**Temporary Shop and Services for a Period of 3 Years**  
**Lot 240 S.B (Part) in D.D. 385, So Kwun Wat, Tuen Mun, New Territories**  
**(Application No. A/TM-SKW/137)**

Table A: Responses to Departmental Comments

Revised Layout Plan 的截圖

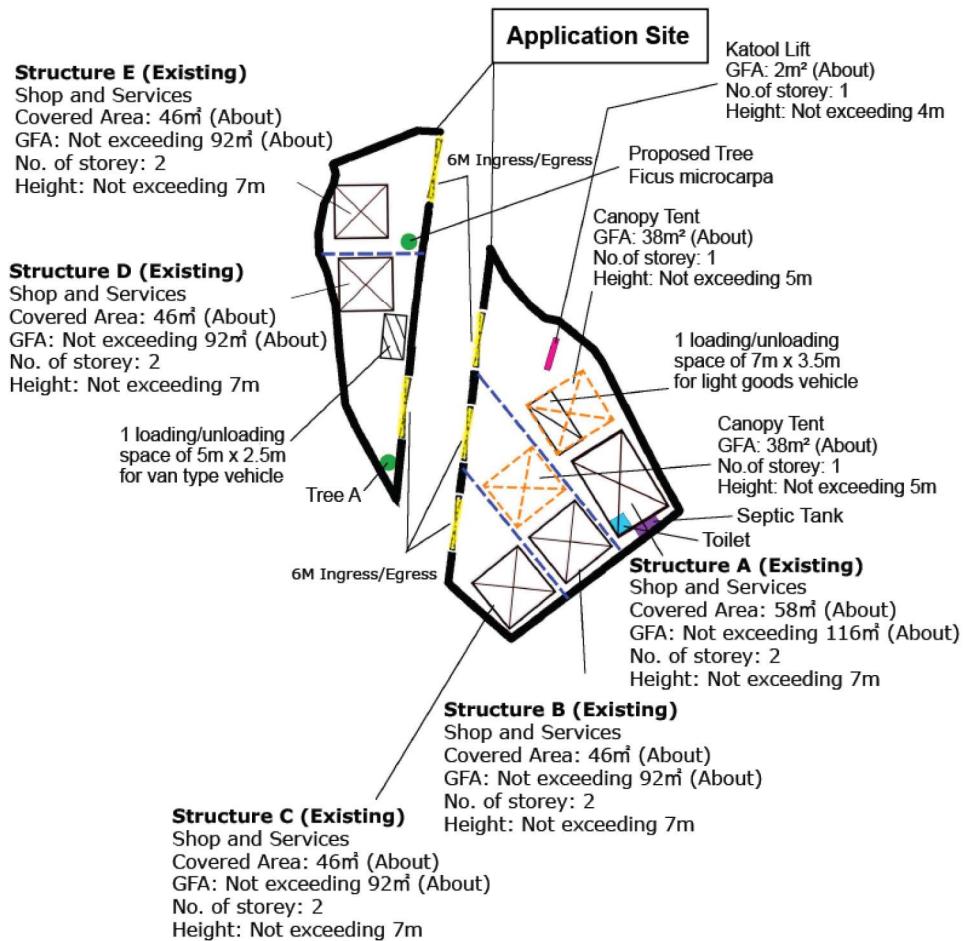
Departmental Comments	Responses
	Transport Department	
(1)	According the application documents, there would be two vehicular accesses. Please indicate them on the drawing.	申請地點分成5個獨立的商店，下圖藍色虛線是現場已存在的圍板，每個商店都是獨立的，不能互相貫穿，每個商店都設獨立的行人或車輛出入口（請看下圖黃色位置，構築物A及D的是車輛出入口；其餘3個是行人出入口）。因此申請人需清楚在Layout Plan上標示，讓大家都清楚知道每個商店的出入口，讓不同的客人能在不同的出入口進入不同的商店。 請看 <a href="#">附件3</a> ：Revised Layout Plan。
(2)	In general, no restriction would be specifically imposed for location of pedestrian access. Hence, please remove pedestrian accesses from the drawings.	
(3)	Please provide swept path for vehicles moving in and out the site.	請看 <a href="#">附件6</a> 。
